Published date	13/02/2019
Document number	SUPAIR_2019/02/001
Page number	1 / 2

Safety info

SUBJECT : Front reserve container standard

FRONT RESERVE CONTAINER STANDARD

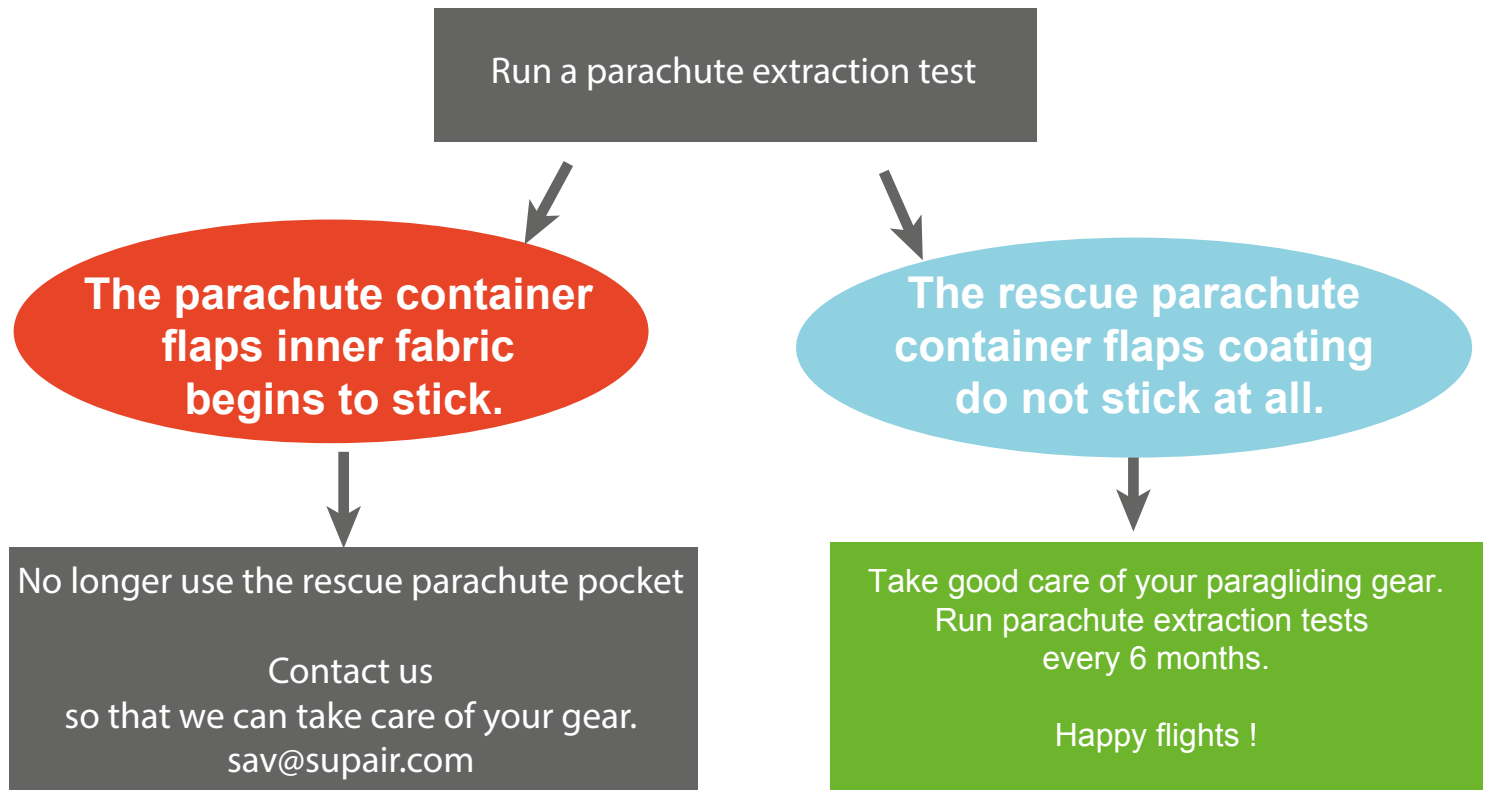
The coating on the rescue parachute container flaps might become sticky.

The coating of the black Cordura might deteriorate overtime and become sticky. It is possible that the degraded rescue parachute container flaps affect the parachute extraction, making it harder or even impossible.

Manufactured between 2007 and 2008

During their yearly parachute extraction test, several pilots noticed that the rescue parachute container flaps had become sticky.

(Fabric defect as regards to the stability of the coating overtime)

DELAIS : **The inspection must be done immediately**
